PLANNING TECHNICAL REVIEW COMMITTEE –AGENDA

TECHNICAL REVIEW COMMITTEE MINUTES – P21-37

TO: Donna Benton, Planner, City of Dover **DATE:** 6/3/2021
FROM: Neil J. Rapoza, PE
CIVIL CONSULTANTS
SUBJECT: One First Street Redevelopment - TRC Response Memo
PROJECT: 20-279.00 One First Street, LLC (Dover project #P21-30)

PROPOSED
FIRST STREET
UTILITY PLAN
PROJECT NO: 20-279.00
DOVER PLANNING FILE: P21-30
L5
SHEET: 7 OF 15

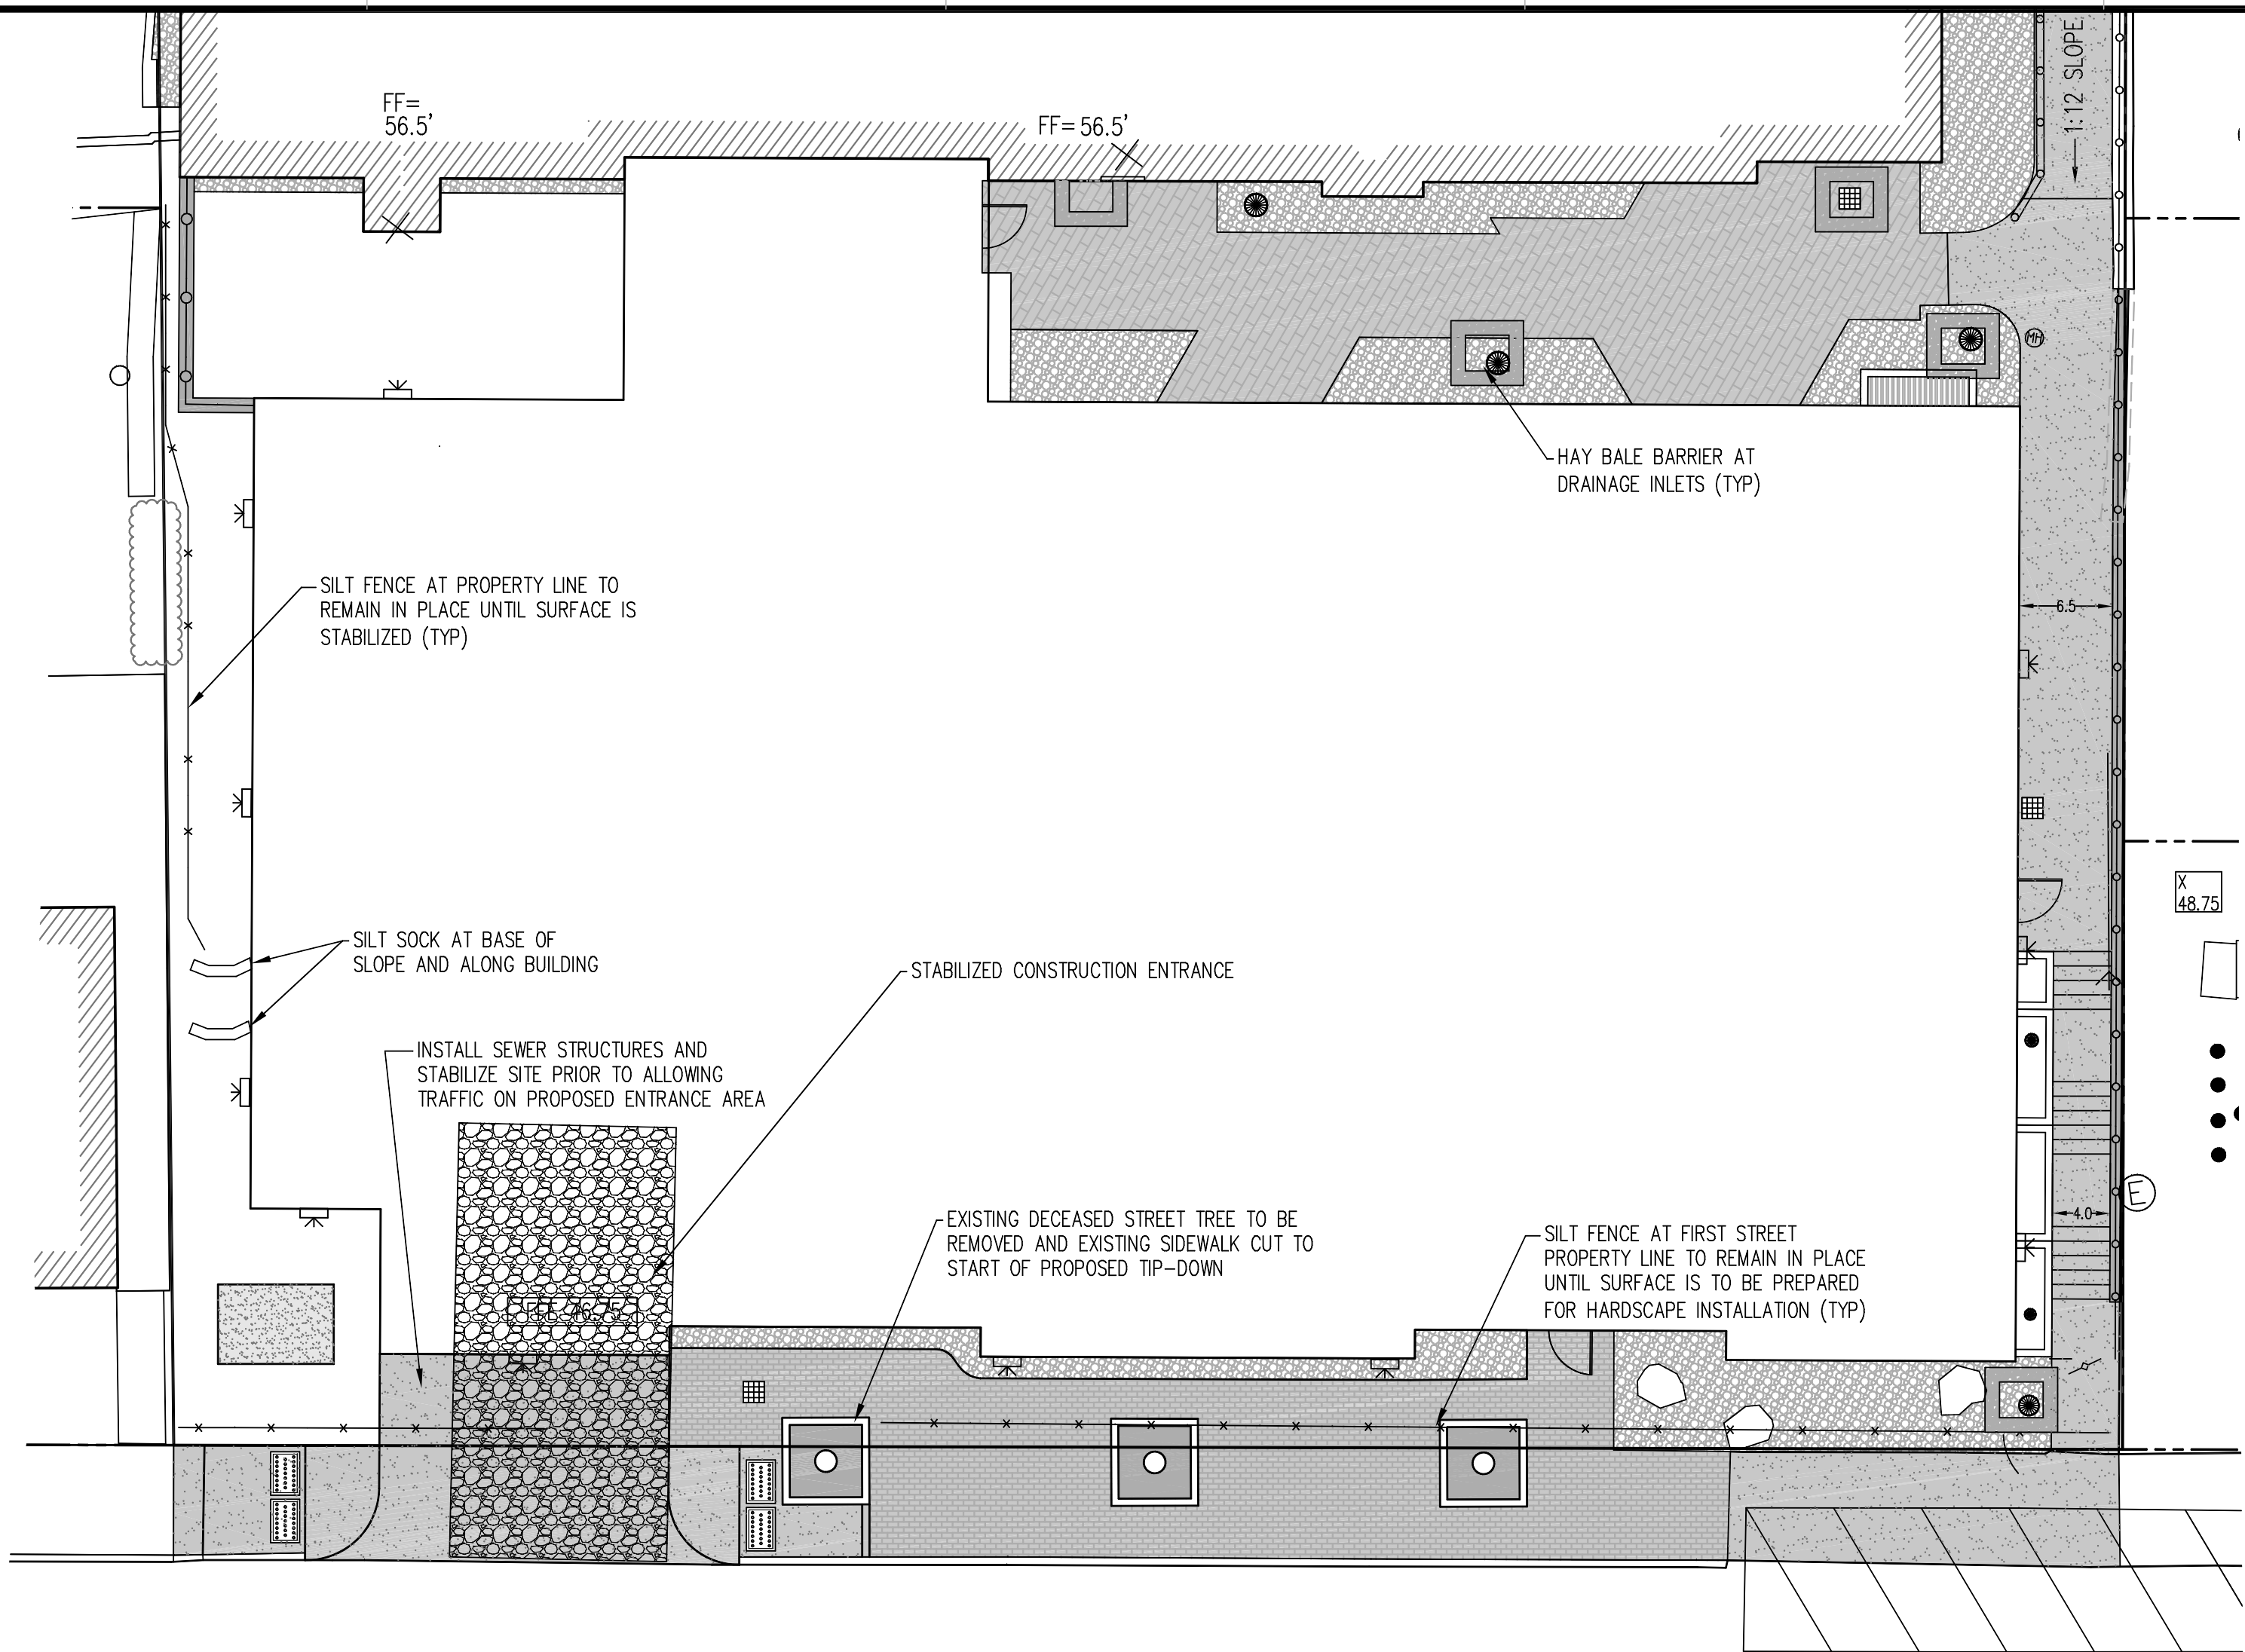
39. Clarify exit from parking garage and stairwell enclosure on L5 does not appear to exit the building.	<i>The stairwell in question has been relocated and the resulting egress locations are now indicated on sheet L2 and L5. A personnel door is now located in the area formerly occupied by the stairwell on the First Street side of the building. See provided floor plans.</i>

1 ROOF PLAN
1/8" = 1'-0"

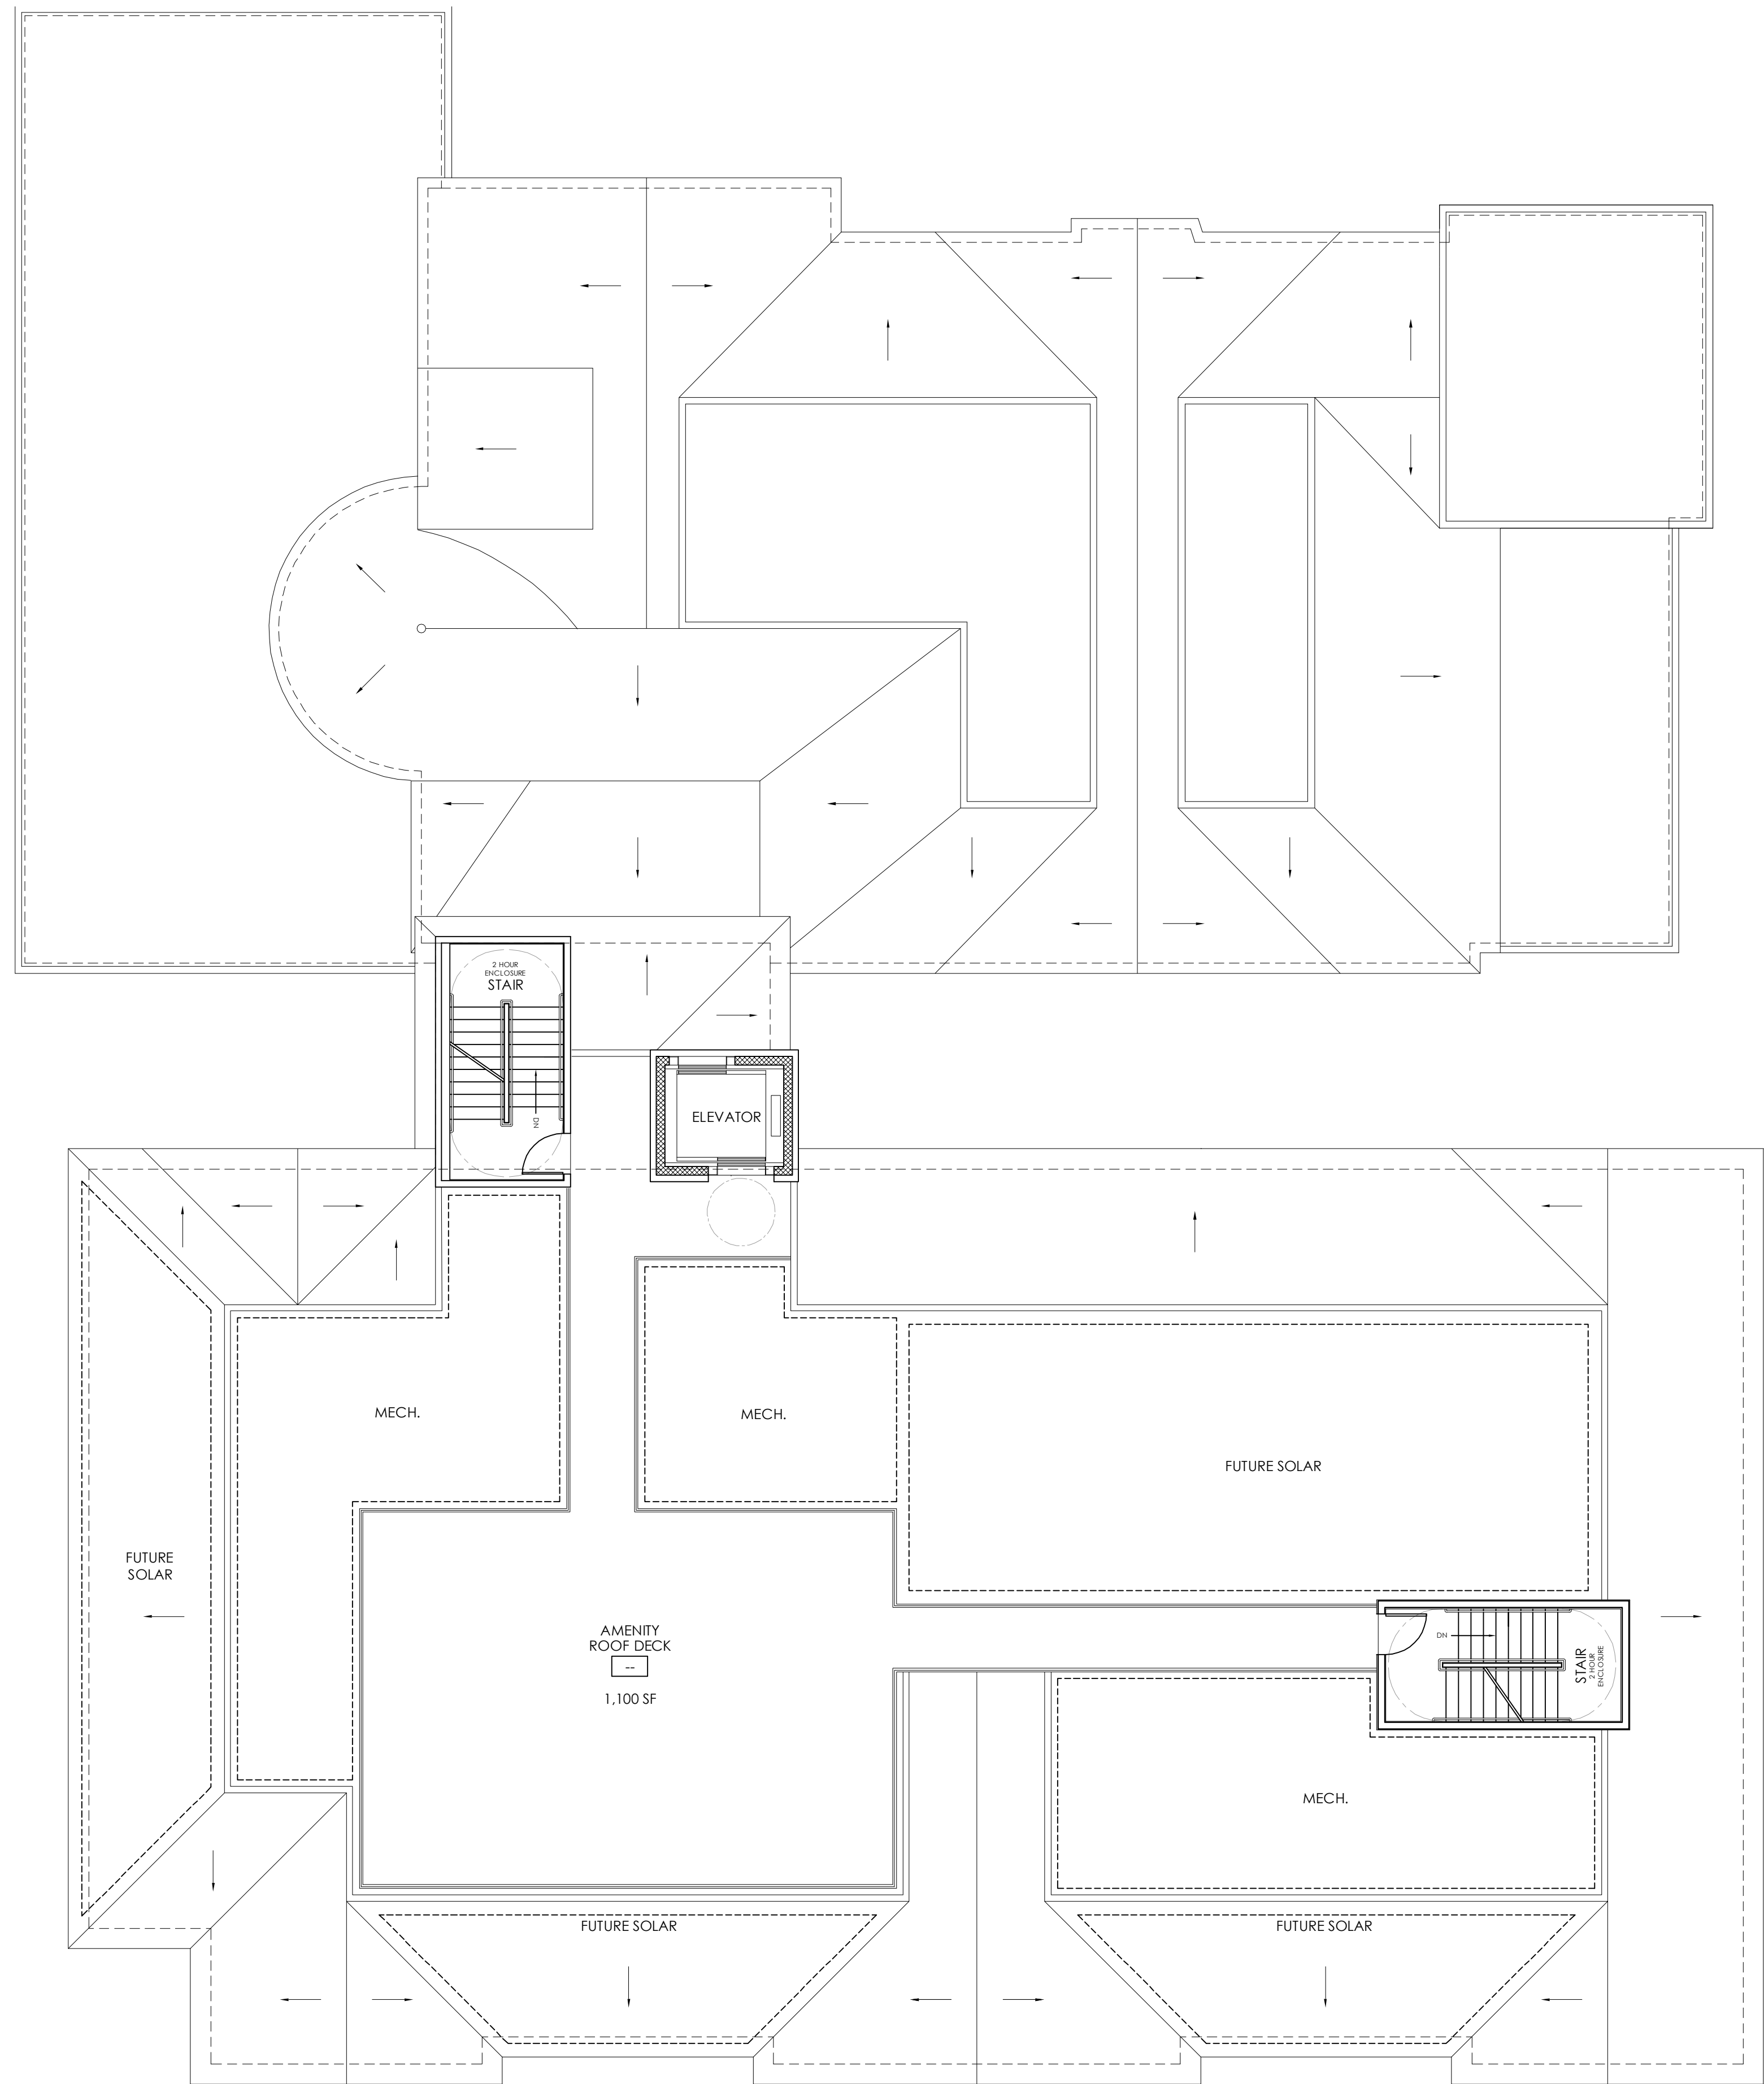
50. Provide roof deck plan	<i>See provided roof plan.</i>
<u>Police:</u>	
51. Looking for explanation of access points. What is the "main" entrance? 2nd street or the alley way? Is there an emergency access on 1st? Police and EMS/Fire access. Access for emergency services in alleyway in winter months can be tricky.	<i>It is the intention that all emergency access will be via the entrance on Second Street. This will allow EMS to utilize the new accessible walkway for ease of travel. The garage will also be accessible if needed. No access for emergency services is proposed at the alley locations.</i>
